DOCKETED
12-CAI-3

DATE: August 2, 2012**TO:** Interested Parties**FROM:** Mary Dyas, Compliance Project Manager**SUBJECT: El Segundo Power Redevelopment Project Complaint (12-CAI-03)**

EL SEGUNDO POWER REDEVELOPMENT PROJECT COMPLAINT (12-CAI-03) STAFF REPORT

Figure 1f: Landscape Concept Plan from the September 2002 Final Staff Assessment

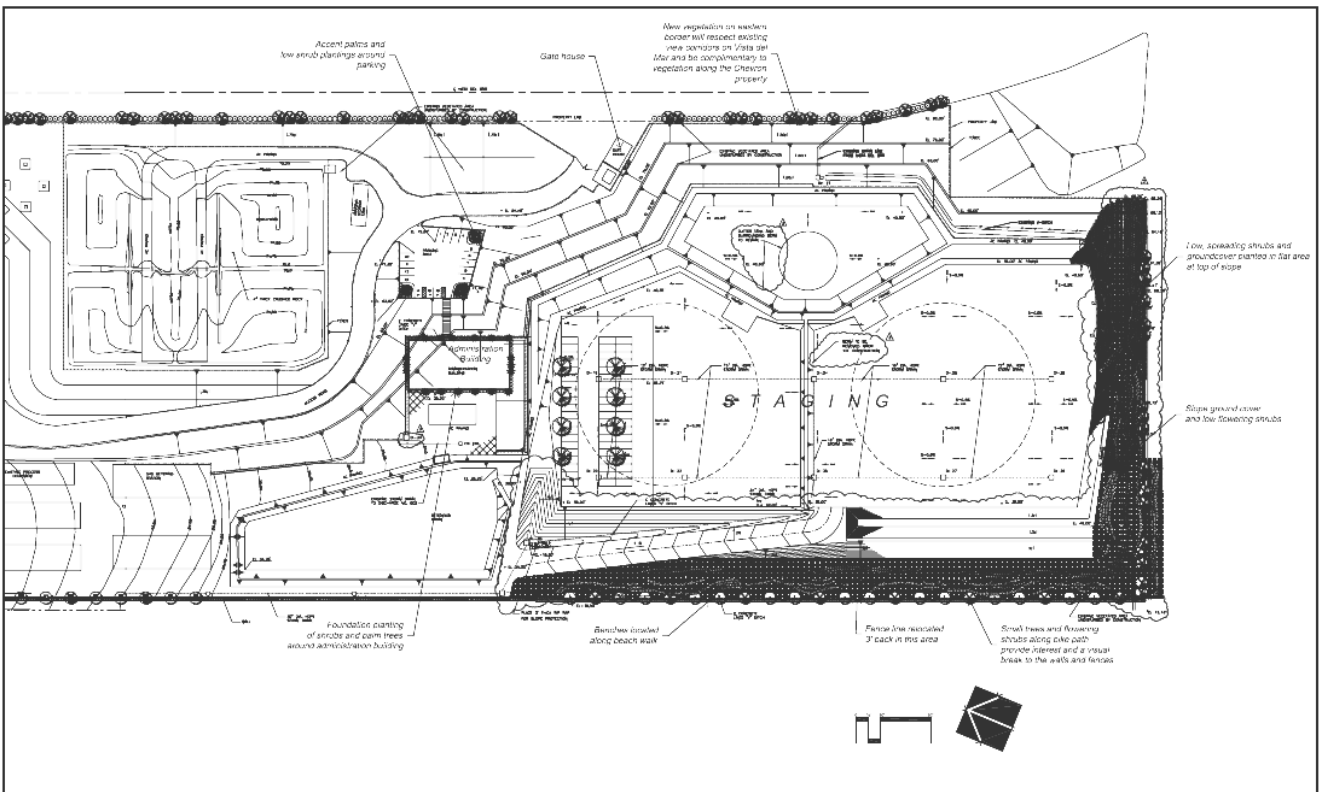
VIS-2 in the Commission's 2005 and 2010 decisions states that the "Landscape Plan shall be consistent with the Landscape Concept Plan presented at Evidentiary Hearings...." (Page 184). Staff assumes the concept plan referenced in VIS-2 is the plan reproduced in the Final Staff Assessment as Figure 16B (shown in this report as Figure 1f). This plan does not clearly depict a fence line. The updated landscape plan approved by the CPM on April 10, 2012, also did not depict the fence along 45th Street. However, plans submitted in 2007 and approved by the CPM in 2008 show a fence line that varies from its distance to the curb, but further back from 45th Street in certain

locations than where it was installed. The present location of the chain link fence is non-compliant with the conditions of certification and CPM-approved landscape plans.

Figure 5a: Asphalt road leading to new berm and side view of concrete spillway.

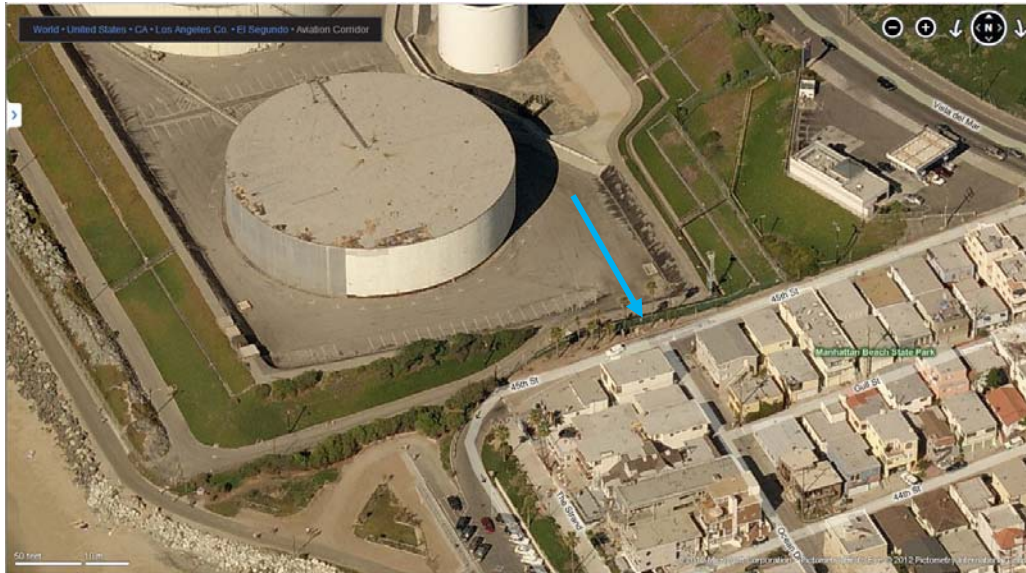
Complainants state that NRG has started to construct an asphalt road along the southern boundary of the property ending on the top of the berm near the tank farm. This road is not depicted on the CPM-approved landscape plans, which show the tank road to be constructed along the western boundary to the tank farm area. **Figure 5a** shows the road questioned in the Complaint. It also appears in the Google Earth image taken prior to construction of the berm (**Figure 5b**). It may be that it was recently paved, possibly in connection with the installation of the concrete spillway. It is not a feature in the approved landscape plans. It may be in use solely for construction access. Staff needs more information to determine if this complaint is valid and whether the road is non-compliant with the CPM-approved plans. It may have also been constructed solely for access for construction vehicles and delivery of soil for the berm construction, and eventually used for delivery of plants to the completed berm.
